**Refers to Item #1
Public Hearing of December 10, 2019**

MEMORANDUM

SUBJECT: CD-1 Rezoning: 6161 Cambie Street (Alliance Francaise) – minor changes to height and density related to a skylight and added washroom and storage space

Figure 1: Sections from 2018 submission and current skylight proposal

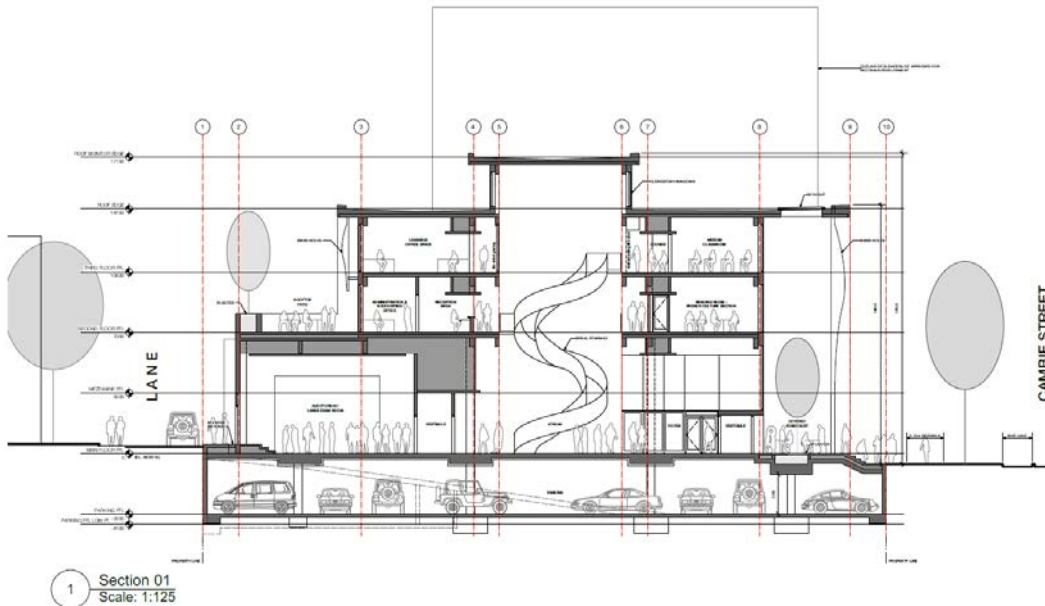
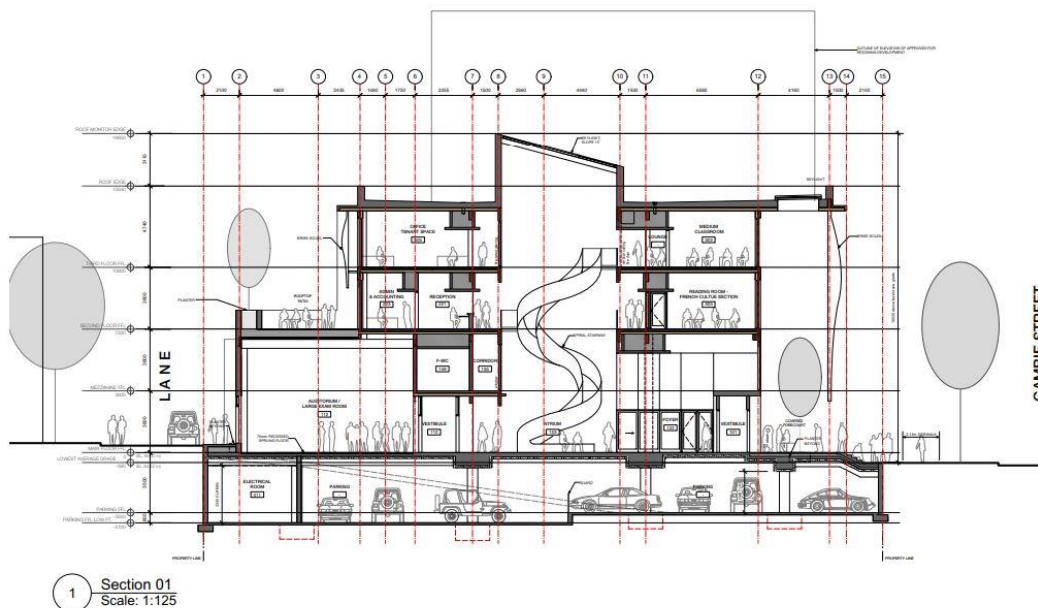
After referral to public hearing on November 5, staff became aware of the design evolving for this site as the applicant is preparing for a development permit submission, should the rezoning be approved. The improved design includes the addition of washrooms and storage space on a mezzanine level and the inclusion of a skylight element on the roof.

The now-proposed skylight element on the roof would require a relaxation of the proposed building height of 17.2 m described in the Policy Report to 18.7 m. Staff have prepared the draft

CD-1 By-law with added wording to the Height section which would allow for a skylight enclosure to extend to 18.7 m in height. This is supportable because the skylight element would add to the liveability of the building and the resulting adjustment to the shape of the roof would be relatively minor.
